WINSOME FILING NO. 3  
PRE DEVELOPMENT GRADING AND EROSION CONTROL PLAN  
A PORTION OF SECTIONS 13 AND 24, TOWNSHIP 11 SOUTH, RANGE 65 SOUTH, AND  
A PORTION OF THE WEST HALF SECTON 19, TOWNSHIP 11 SOUTH, RANGE 64 WEST OF THE 6TH P.M  
COUNTY OF EL PASO, STATE OF COLORADO

# Grading & Erosion Control Plan\_V2-redline.pdf Markup Summary

WINSOME FILING NO. 3  
EL PASO COUNTY, COLORADO  
PRE DEVELOPMENT GESC PLAN  
GEC INTERIM PLAN

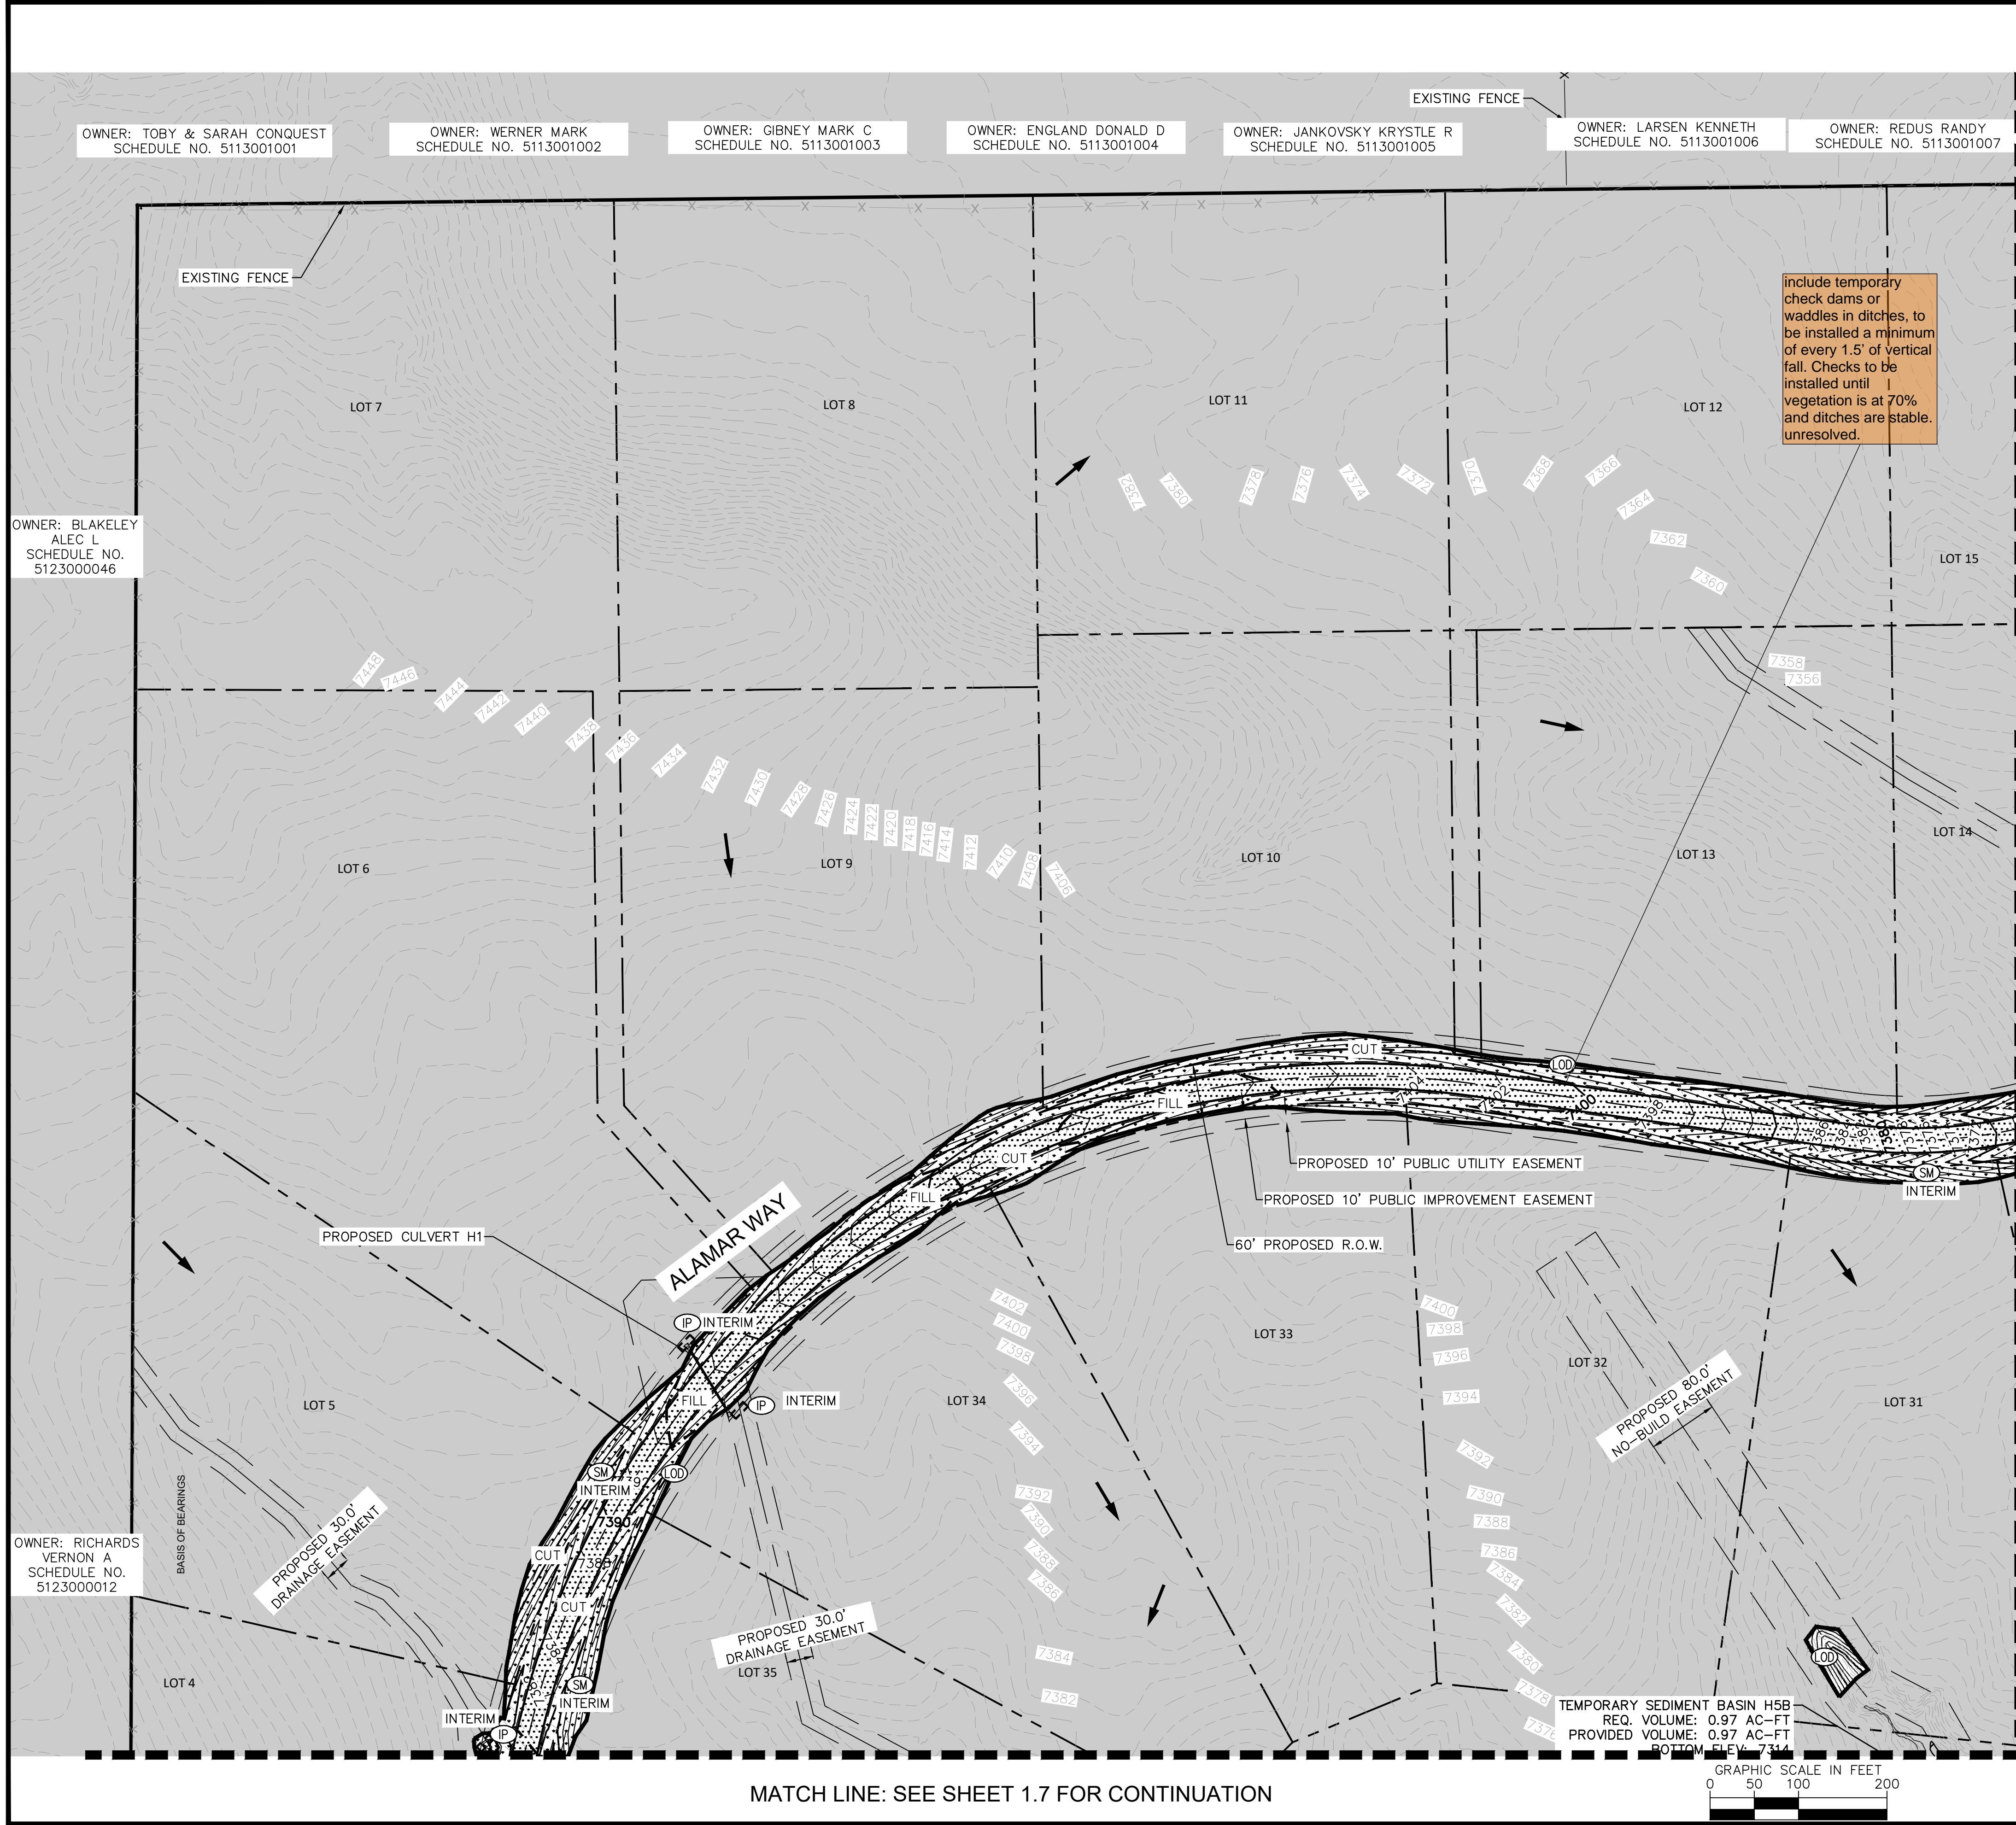
show contours and details for Sediment Basin H5B or note that it will be  
installed under a separate filing. adjust text and leader so it is not cut off from  
this sheet. include in area of disturbance if installing with the EGP filing.
